SERVICE BULLETIN SB-00031

Date Released:	November 24, 2020
Date Effective:	November 24, 2020
Subject:	RV-8/8A Quick Build Firewall Fastener Inspection and Replacement
Affected Models:	RV-8 QB and RV-8A QB Fuselages
Required Action:	Inspect the four fasteners that attach each WD-803-1 Lower Engine Mount Bracket to the F-834-1 Longerons on each side of the airplane. If the utilized fasteners are AN3 bolts: No further action is required. If the utilized fasteners are rivets: Replace with AN3 bolts.
Time of Compliance:	Before further aerobatic flight (>3g and/or <1g)
Level of Certification:	Owner (certification not required) <i>Check the rules of the local controlling authority/agency and the operating limitations for your aircraft.</i>

FIGURE 1: EXCERPT FROM RV-8 DRAWING 67/67A

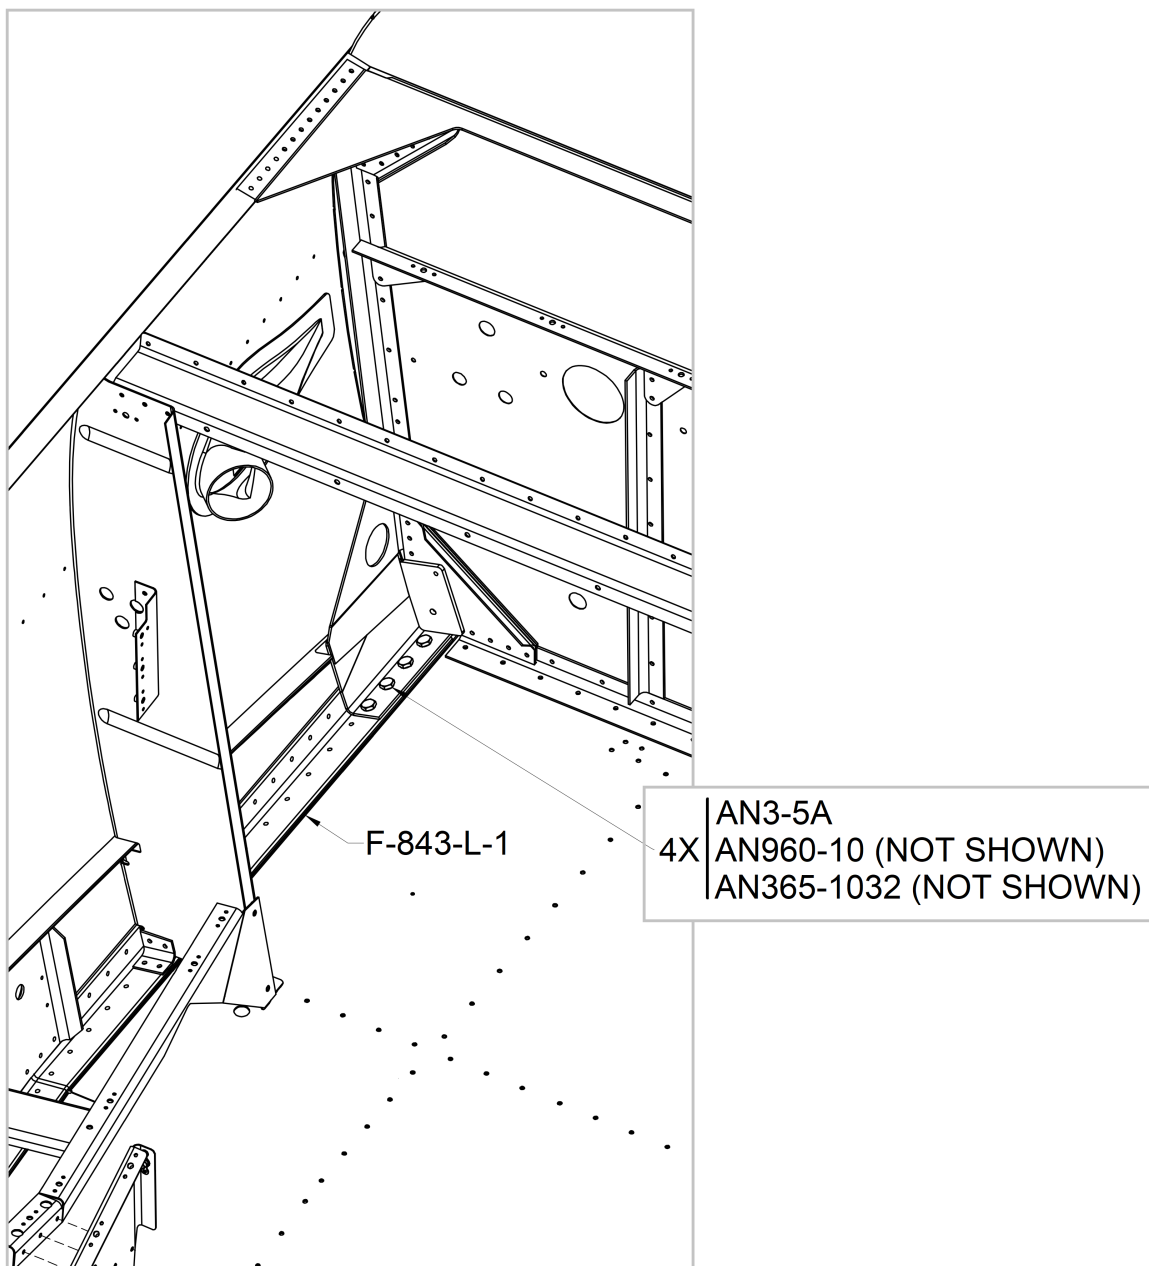
Van's has discovered that in a limited number of Quick Build fuselage kit, four rivets were used to attach each Lower Engine Mount Bracket to the lower longerons instead of the specified AN-3 bolts. Each WD-803-1 Lower Engine Mount Bracket should be fastened to the corresponding F-834-1 Lower Longeron using four AN3 bolts, as shown in Drawing 67/67A (refer to Figure 1, below). To ensure all QB fuselages in the field are assembled with the correct fasteners, inspection is required. Use of these rivets results in reduced strength/capacity of the structural joint, and therefore the rivets - if they are installed - must be replaced with AN3 bolts.

Step 1: Inspect the forward end of each L-843 Longeron (left and right) and determine whether the four fasteners attaching it to the WD-803-1 Lower Engine Mount Bracket are AN3 bolts. If they are, then skip to Step 8.

FIGURE 2: ONE-INCH DIAMETER HOLE LOCATION, FORWARD SIDE OF FIREWALL

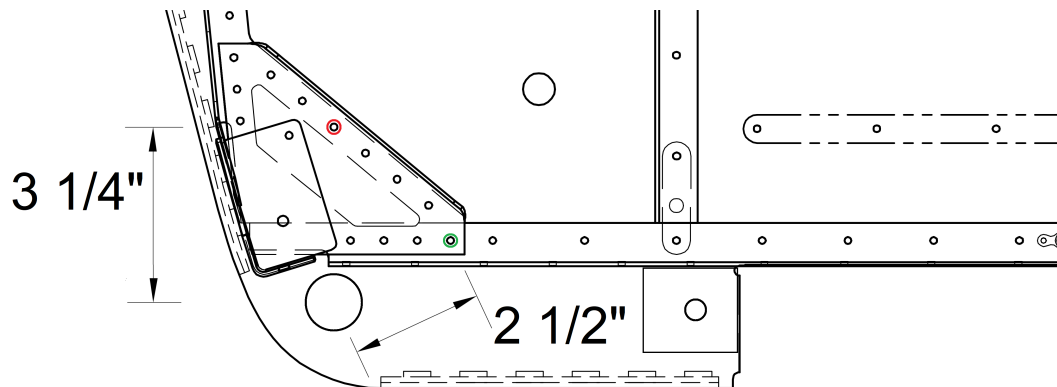
Step 2: Drill a one-inch diameter hole in the lower outboard corners of the firewall, at the location specified in Figure 2, relative to the centers of the holes highlighted in green and red:

Step 3: Drill a hole from inside the fuselage through the aft-most of the four rivets. Enlarge the hole for the AN3 bolt.

Step 4: Insert the AN3-5A bolt through the hole. Attach the AN960-10 washer and AN365-1032 nut.

Step 5: Tighten and torque the bolt from inside the fuselage, while holding the nut with a wrench through the one-inch hole in the firewall.

Step 6: Repeat steps 3, 4, and 5 for the second-to-aft-most rivet, then the third, and finally the fourth. Repeat these steps for the other side of the fuselage, i.e. 8 times in total.

Step 7: Insert an FF 1" FIREWALL PLUG, a snap-in stainless steel plug, into each of the one-inch holes. Seal with fire barrier sealant.
